Application Serial No: 10/814,360
In reply to Office Action of 12 September 2005

AMENDMENTS TO THE DRAWINGS

REMARKS / ARGUMENTS

FIG. 2

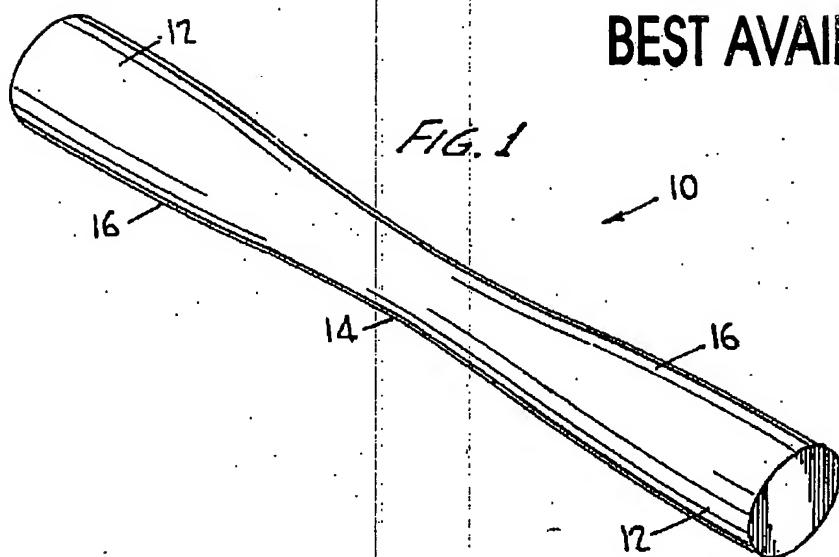
The Examiner objected that Figure 2 of the drawings lacks labeling for the x and y axis. She required appropriate correction including all of the figures appearing on the sheet. She stated that each drawing sheet submitted after the filing date of an application must be labeled in the top margin as either "Replacement Sheet" or "New Sheet" pursuant to 37 CFR 1.121(d).

Please replace sheet 1 of the drawings with the attached replacement sheet. The attached replacement sheet includes x and y axis captions for FIG. 2.

Applicant has corrected FIG. 2, and a replacement sheet is submitted herewith.
